## **ADDENDUM NO. 1**

**Contract No.: RFT 2024-007**

**Tender – Reconstruction of Smith St, Arthur and Construction of Pedestrian Crossovers, Smith St and Main St N, Mount Forest**

|       | No | DATE       | REVISION                           | INITIAL |  |  |  |                            |  |   | DRAWING<br>NUMBER | 05       |

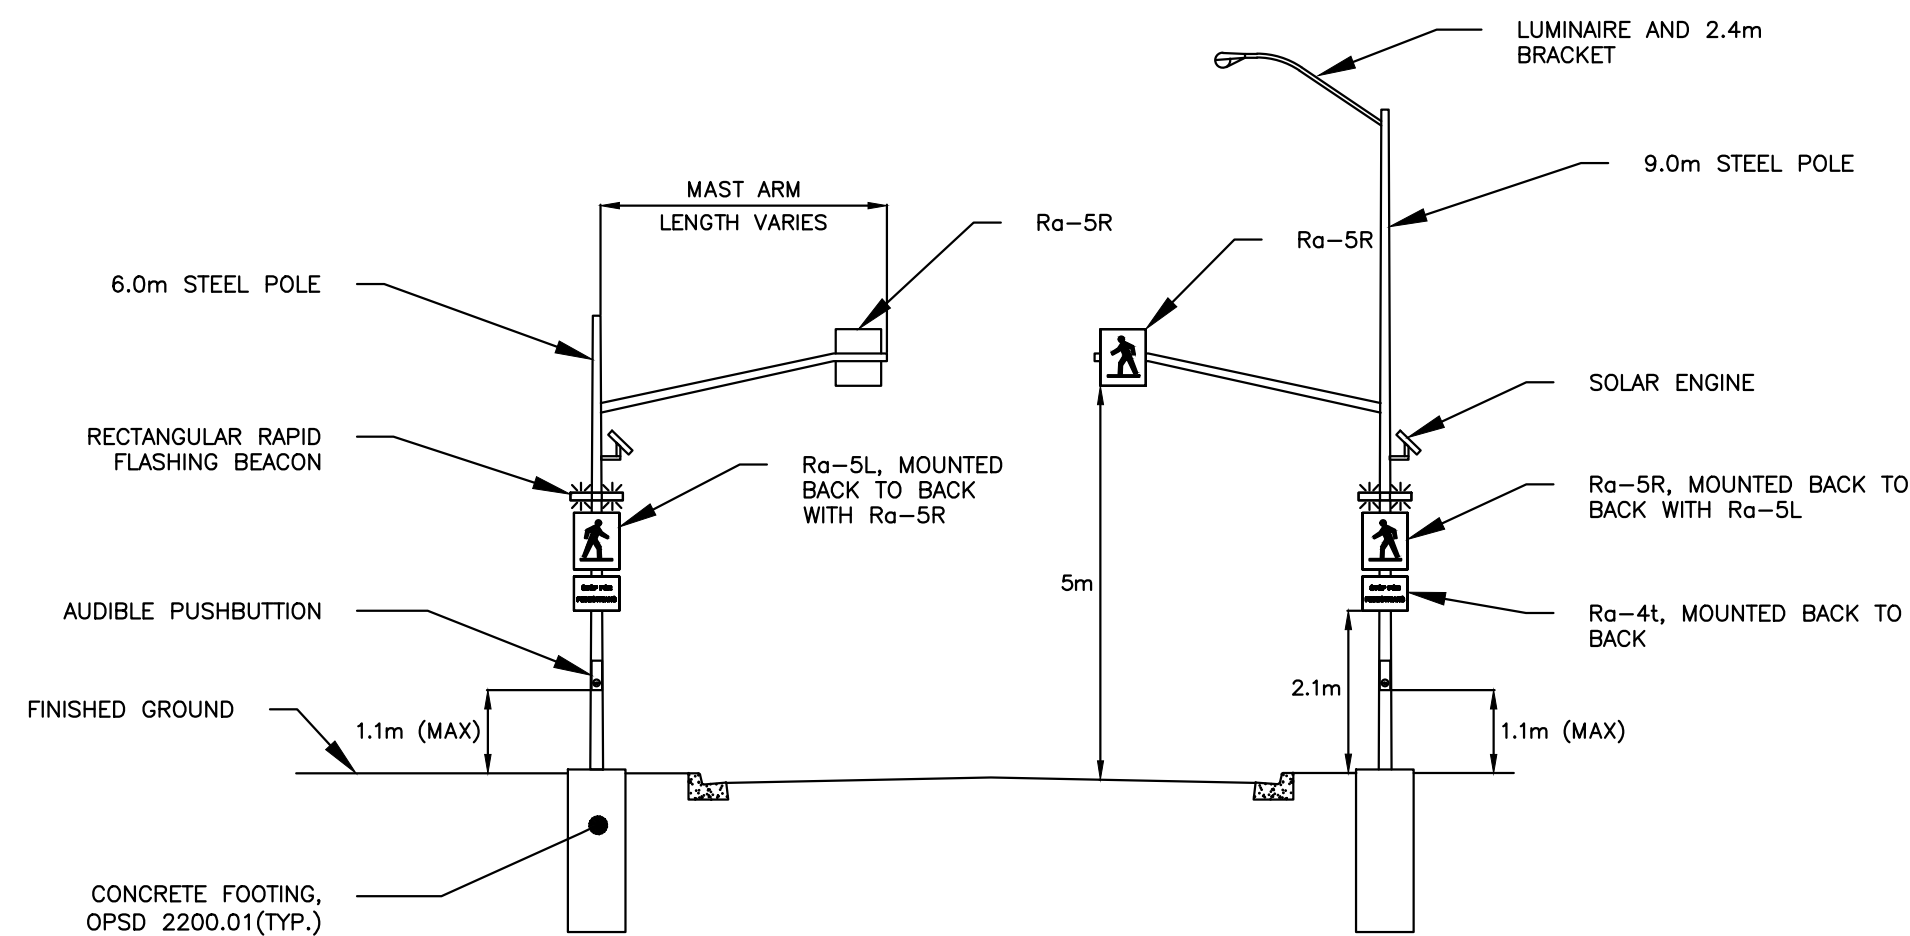
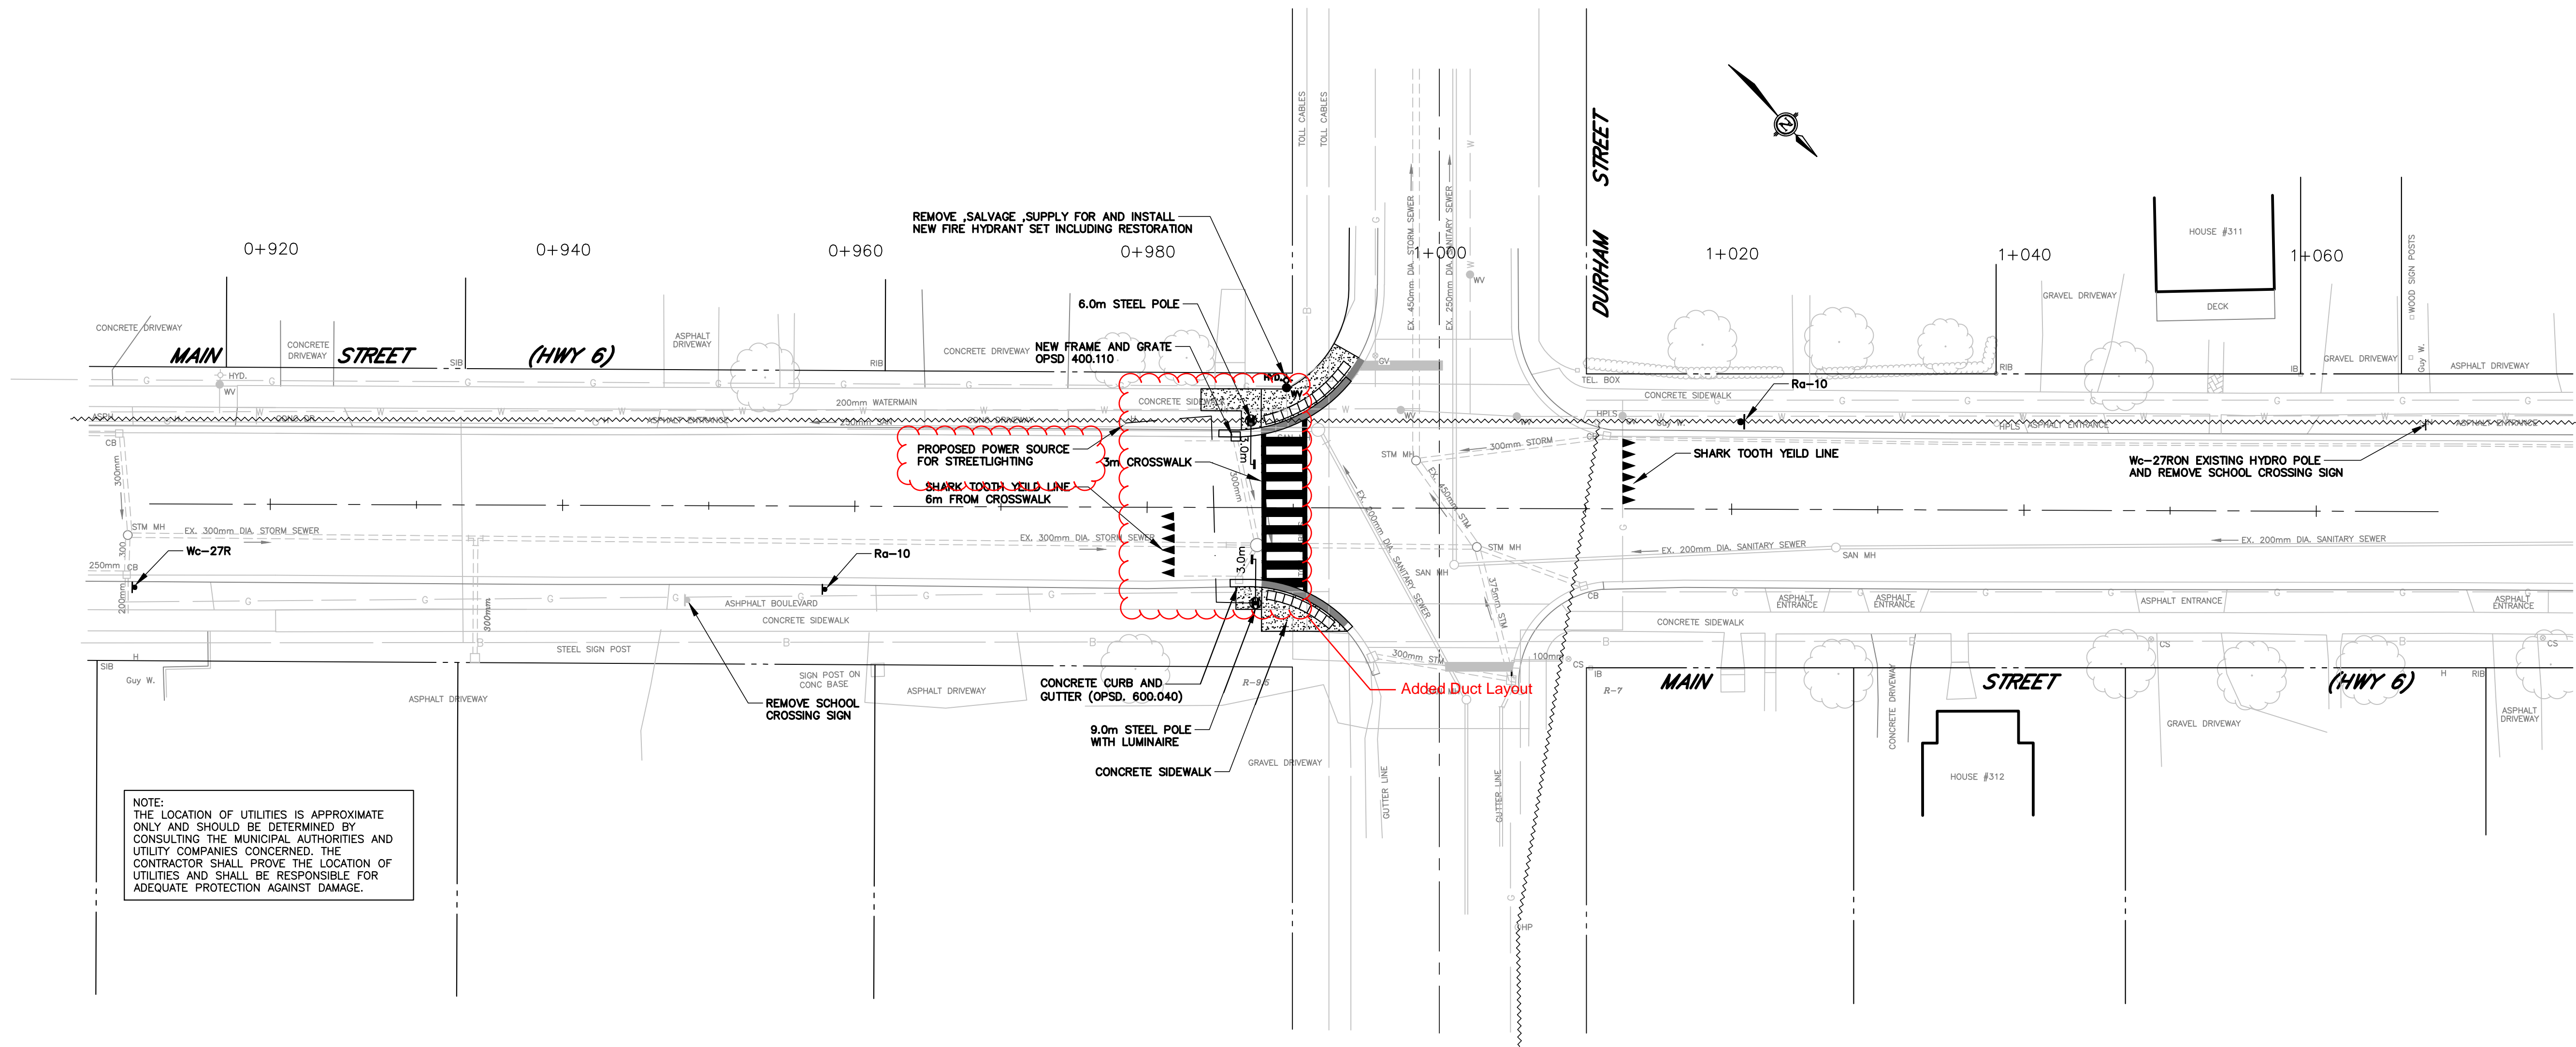
Where is the Streetlight on the southwest corner of Smith St and Conestoga St S being fed from?

The location of the direct buried rigid ducts is not shown on the drawings, can the customer please let us know where will these be installed?

Streetlight is to be fed from relocated hydro pole on Conestoga Street South. Drawing 05 is revised.

Drawing 05 and Drawing 06 are revised to include rigid ducts.

| SCALES            |           |
|-------------------|-----------|
| DRAWING<br>NUMBER | <b>06</b> |

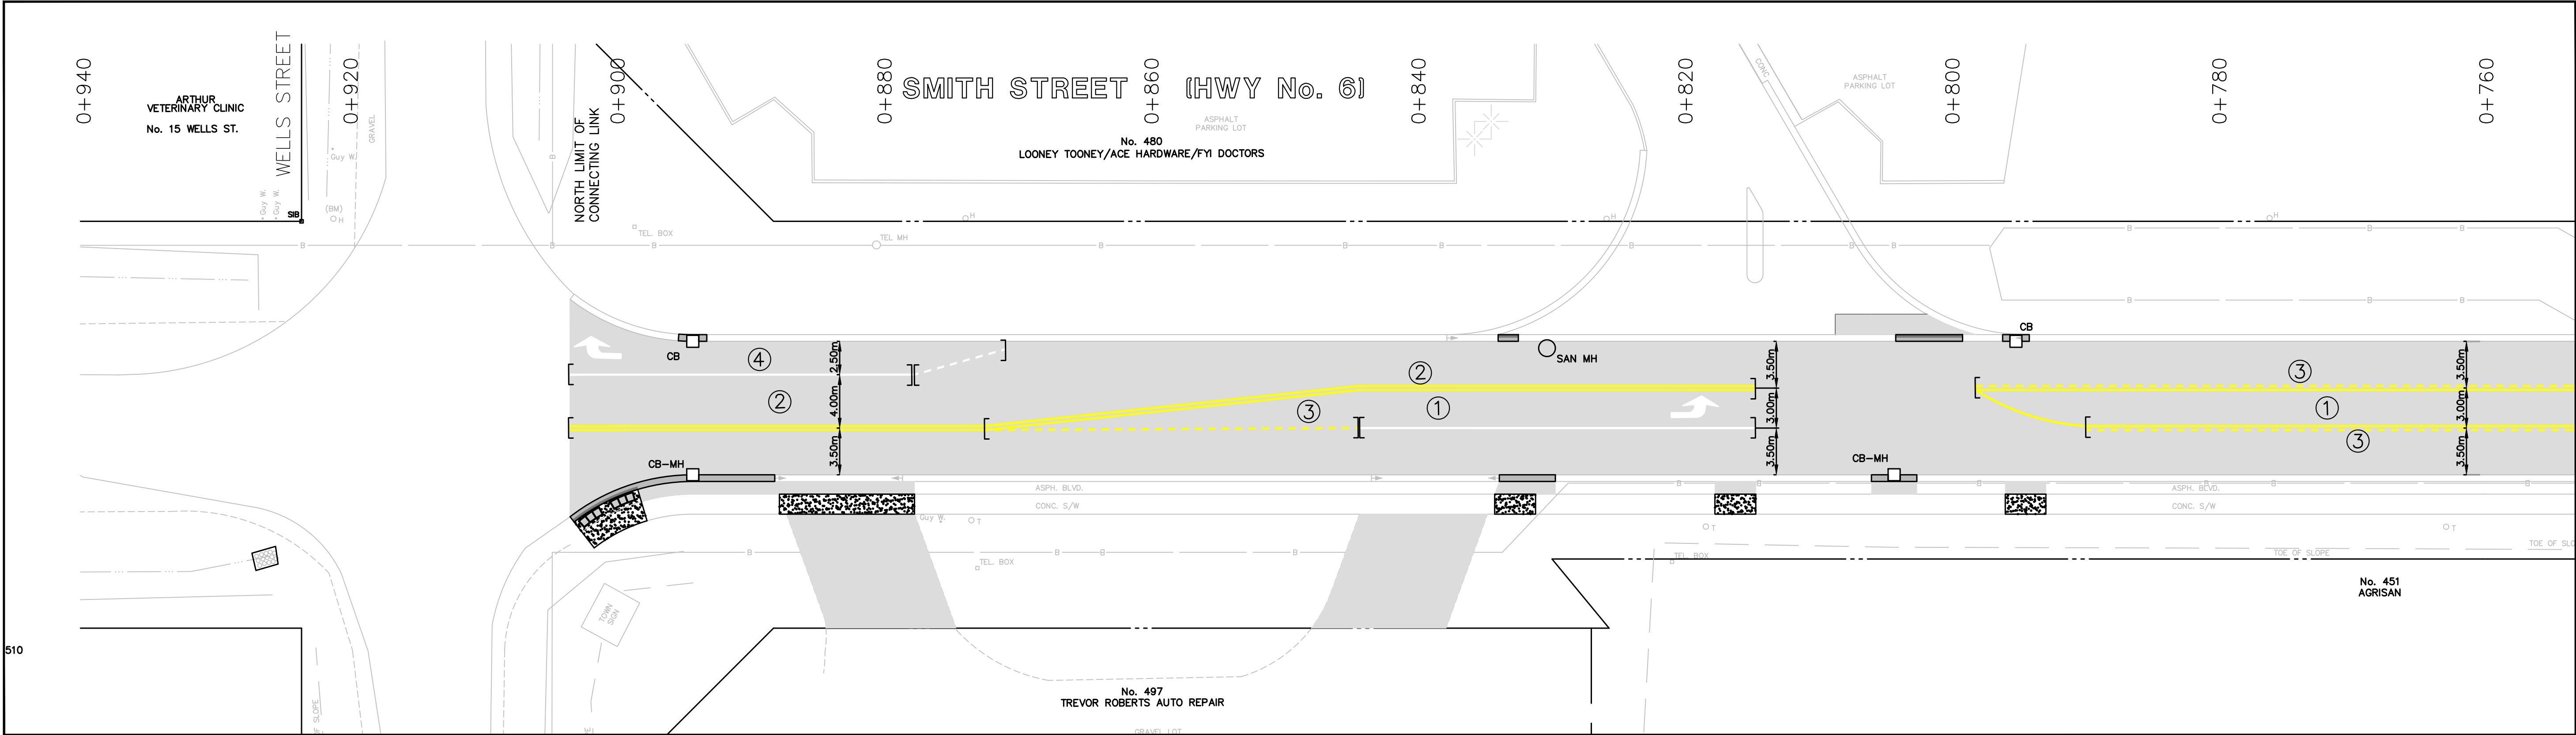
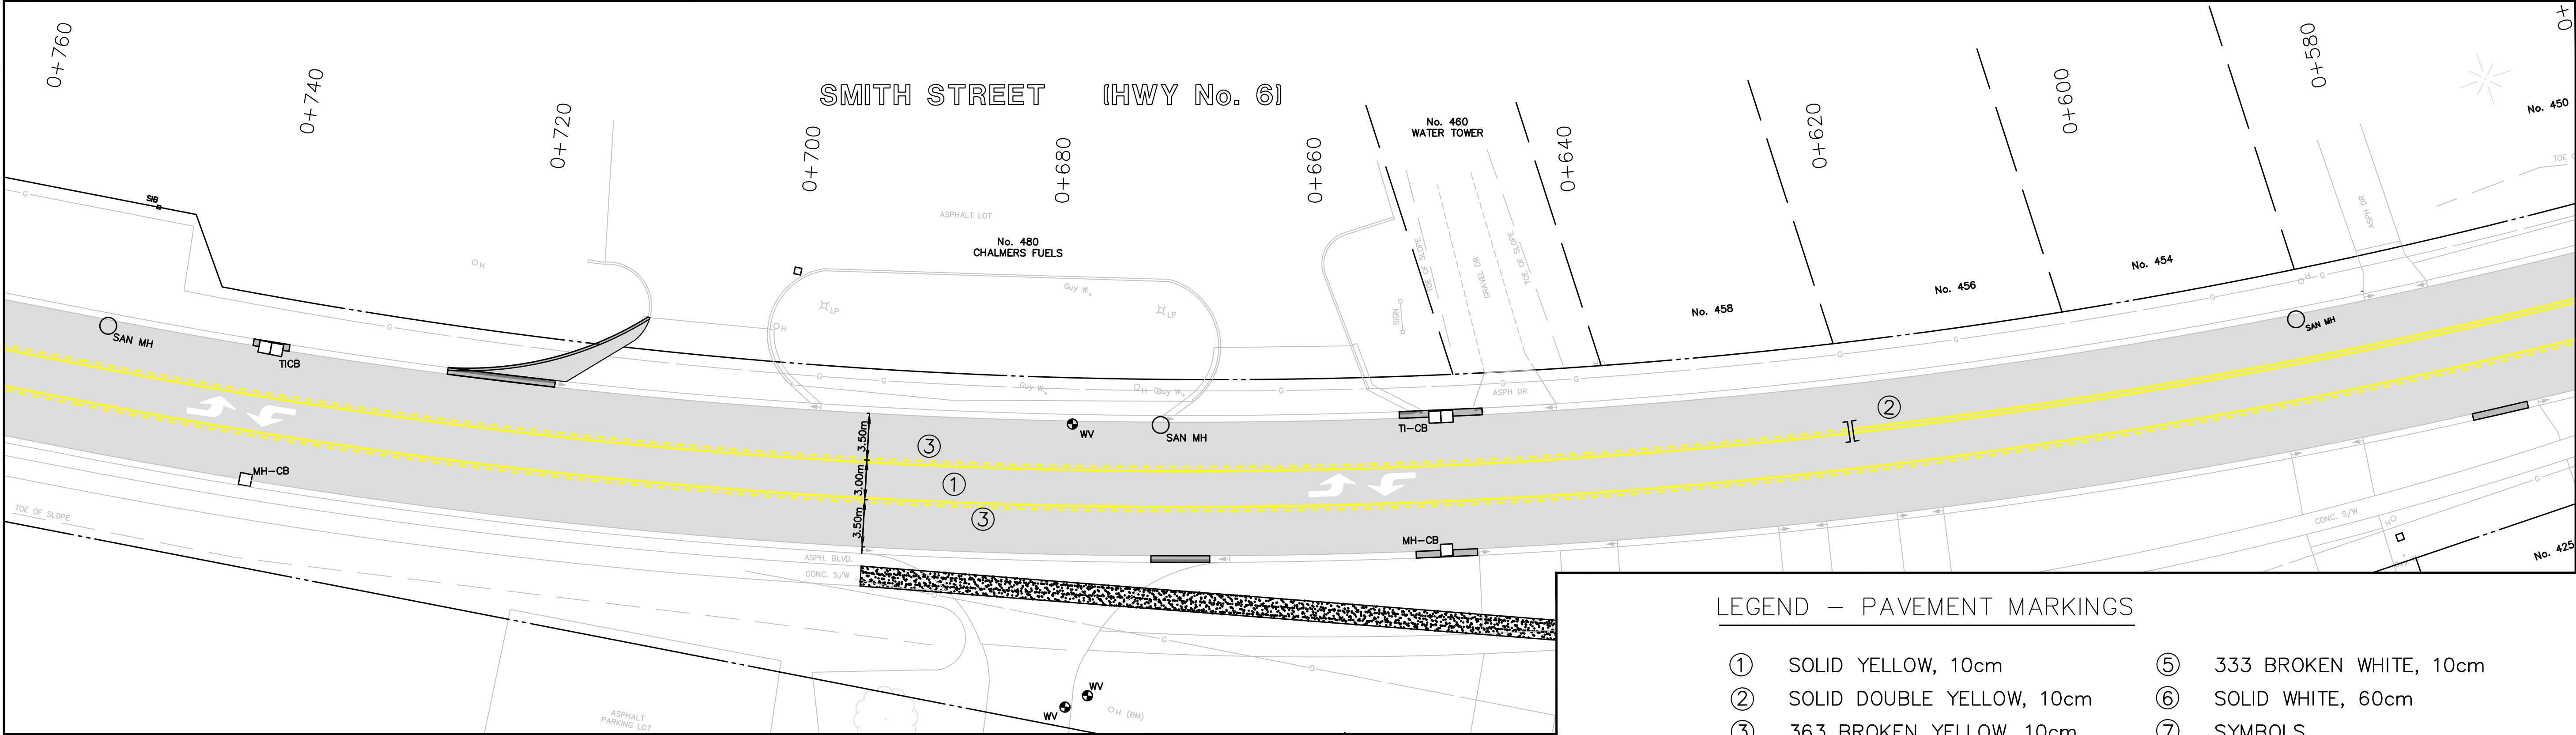
Where is the streetlight on the north side of the PXO crossing at Mount Forest being fed from?

The location of the direct buried rigid ducts is not shown on the drawings, can the customer please let us know where will these be installed?

Streetlight is to be fed from hydro pole on west side of Main Street, south of the intersection with Durham Street. Drawing 06 is revised.

Drawing 05 and Drawing 06 are revised to include rigid ducts.
